**RE: St. Therese School
311 Shropshire Place NW
Grading and Drainage Plan
Engineer's Stamp Date: 06/17/19
Hydrology File: G14D092**

Based upon the information provided in your resubmittal received 06/21/2019, the Grading and Drainage Plan is approved for Building Permit.

HYDROLOGY REPORT NEW MULTI-PURPOSE BUILDING for ST THERESE CATHOLIC SCHOOL

GRADING AND DRAINAGE PLAN NEW MULTI-PURPOSE BUILDING for ST THERESE CATHOLIC SCHOOL

C-101

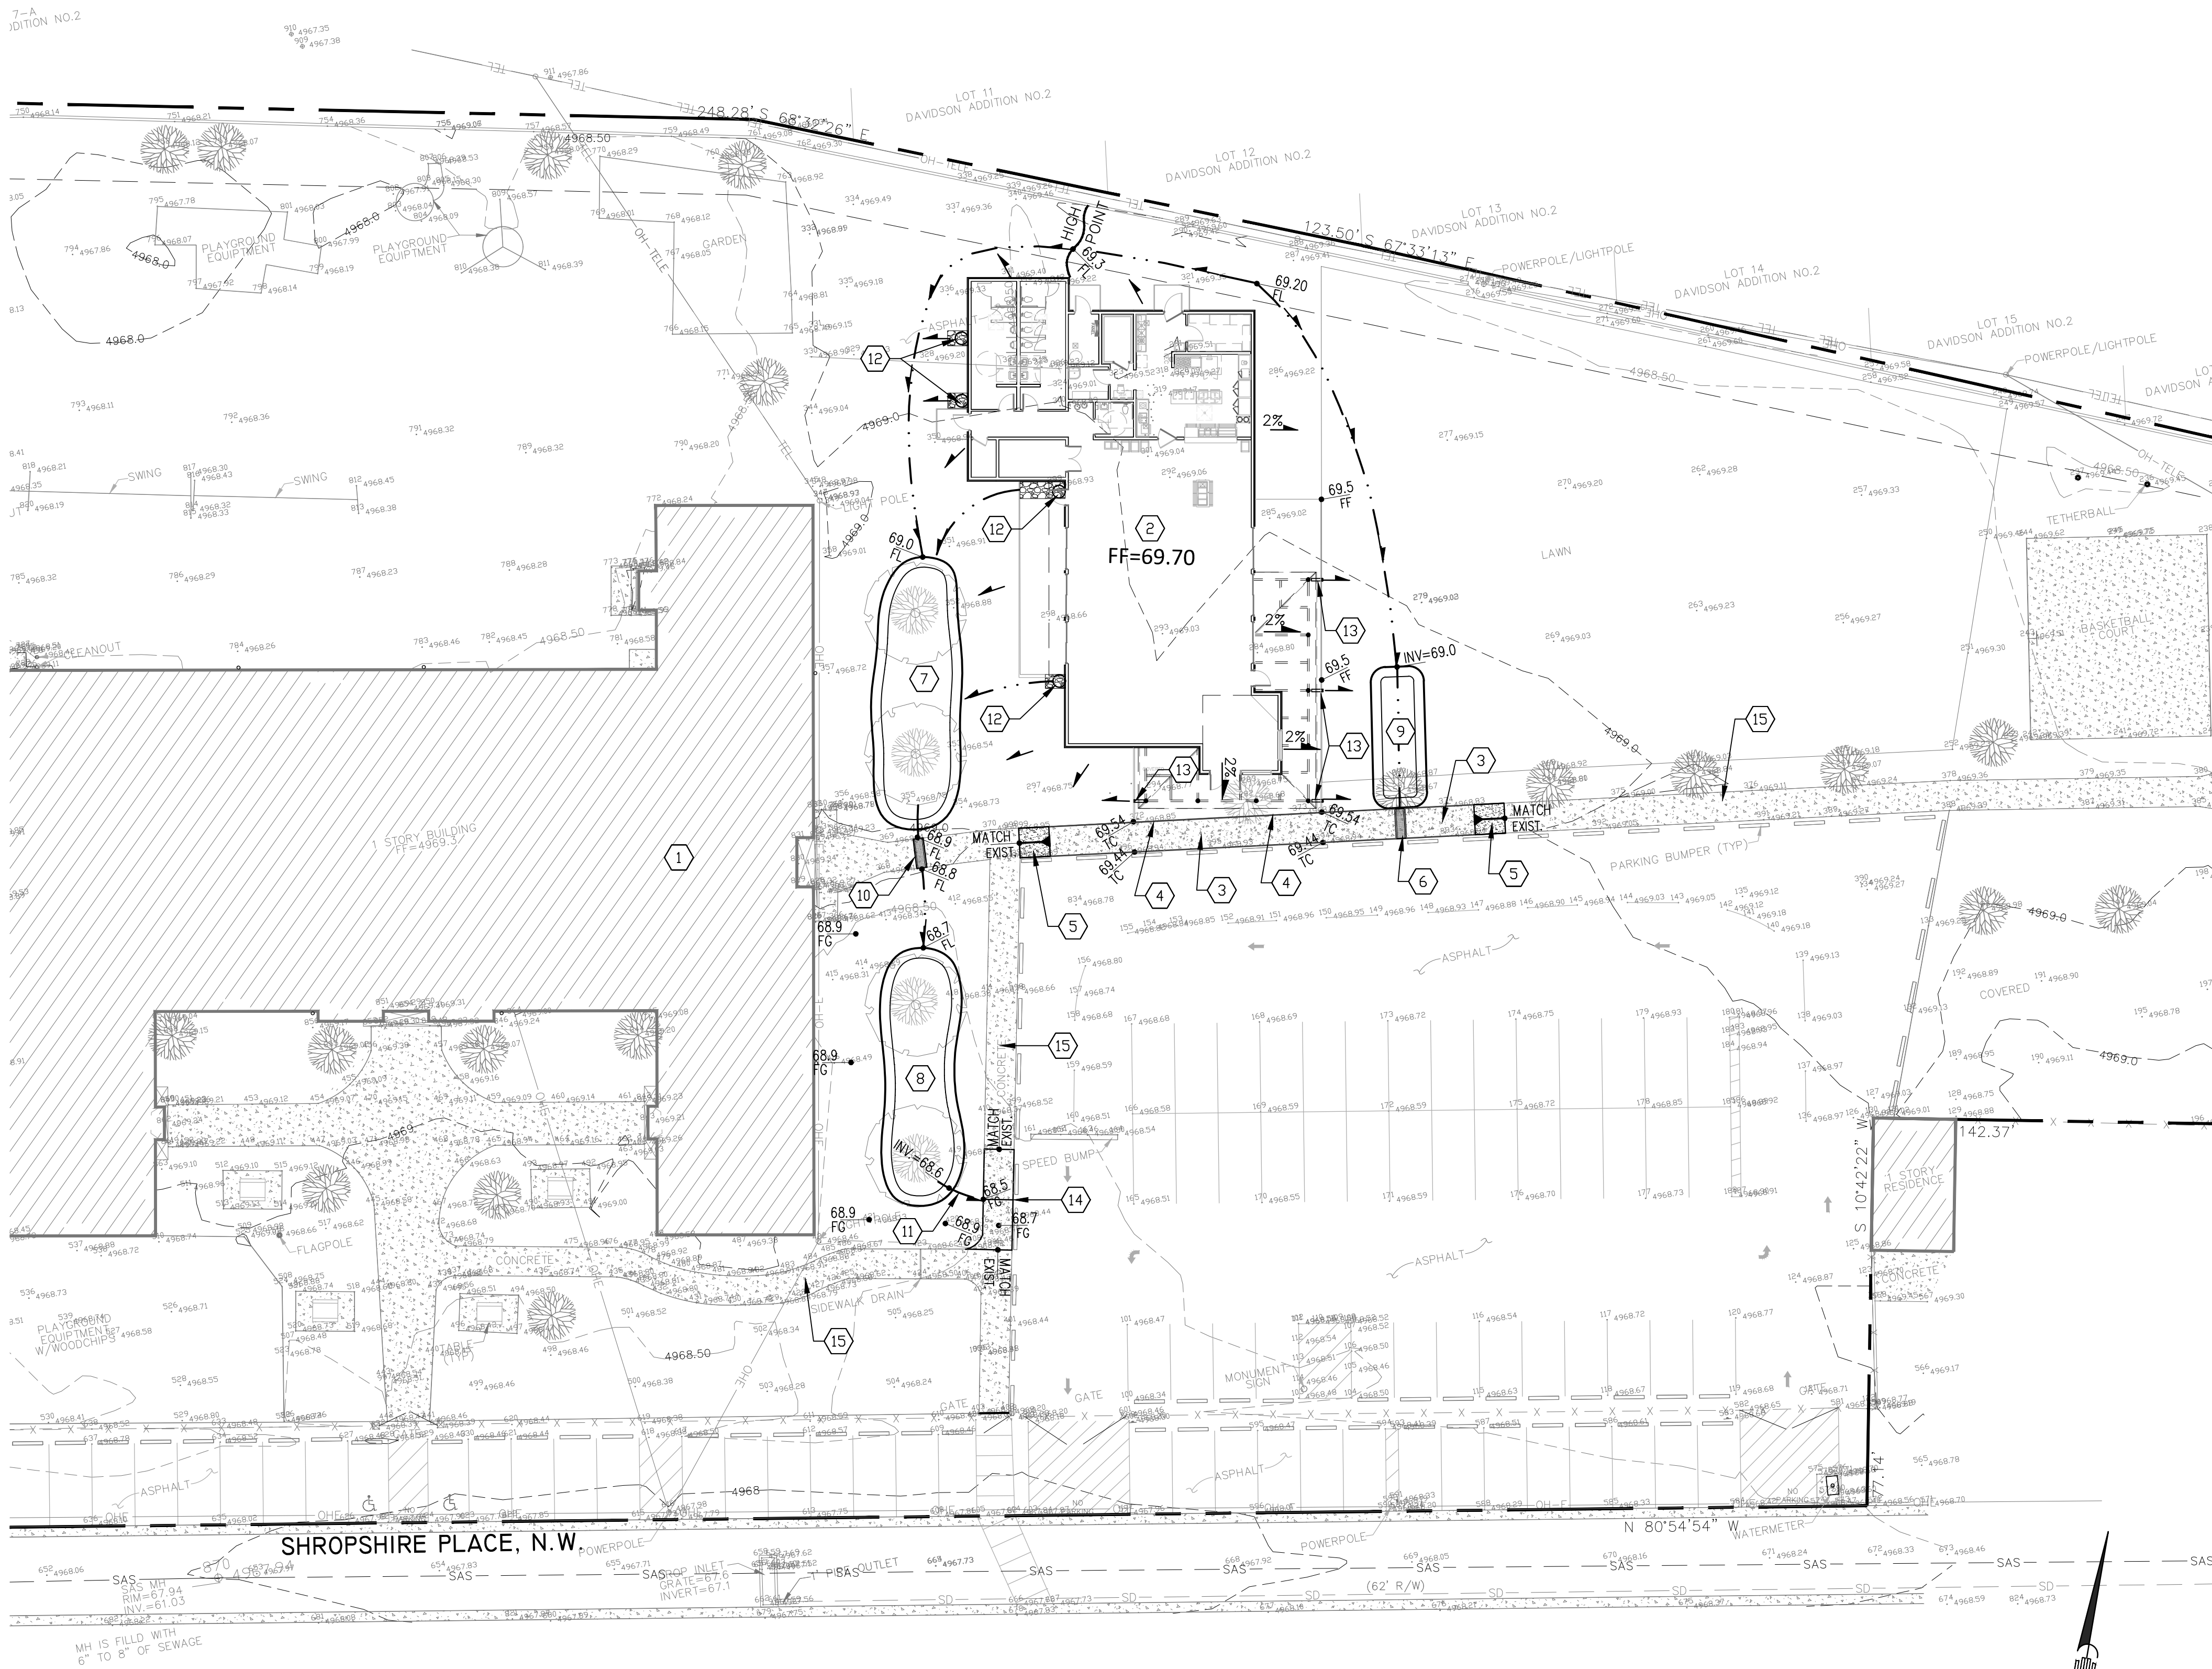
Please provide Drainage Covenant per Chapter 17 of the DPM prior to Permanent Release of Occupancy for the retention ponds. Please submit these to the 4th floor of Plaza de Sol. A \$25 fee for each will be required.
